Development Application No: DA2025/0449 for Alterations and additions to a dwelling house including a swimming pool at 28 Bassett Street MONA VALE.

The assessment has found that it is an overdevelopment of the subject site and unsatisfactory in its current form for the reasons identified below:

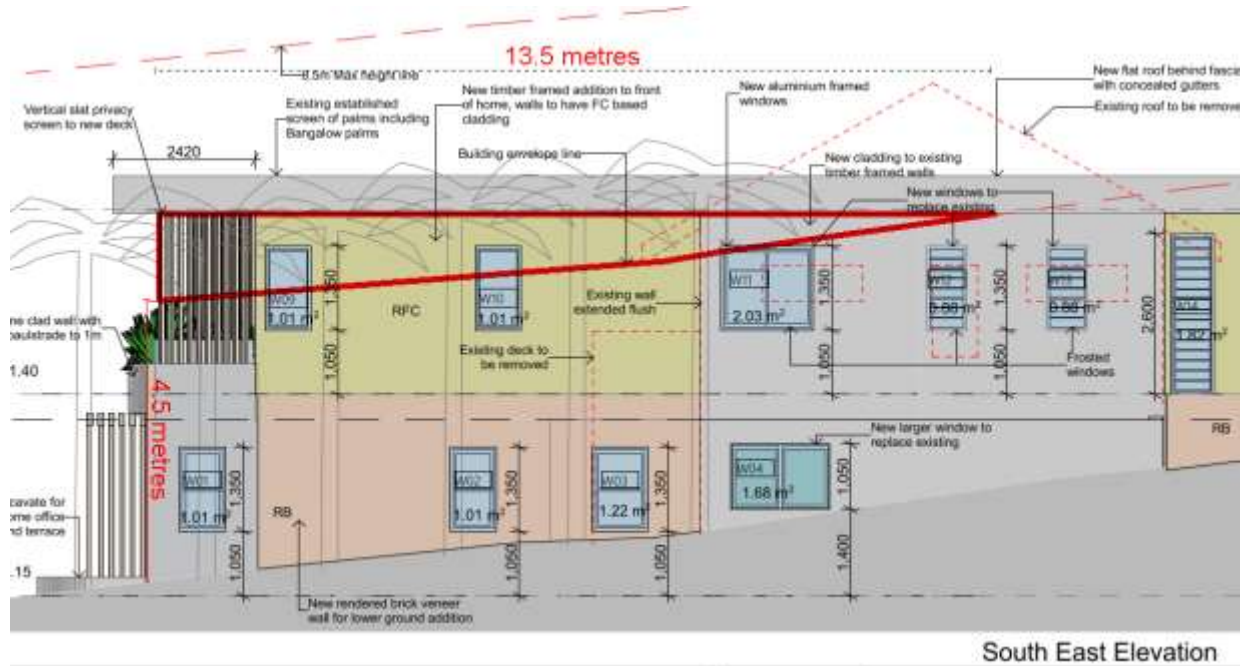
The east and west elevations of the proposed works will be outside of the maximum building envelope permitted under Part D9.9 Building envelope of the Pittwater 21 Development Control Plan (P21 DCP).

In numerical terms, the breaches are estimated at:

West: 20.3m (length) x 1.5m (height); and

East: 13.5m (length) x 1.5m (height).

A representation of these estimated breaches is provided below:

These non-compliances are significant and under the circumstances are not supported. The proposed design is considered to fail the following Outcomes of the control:
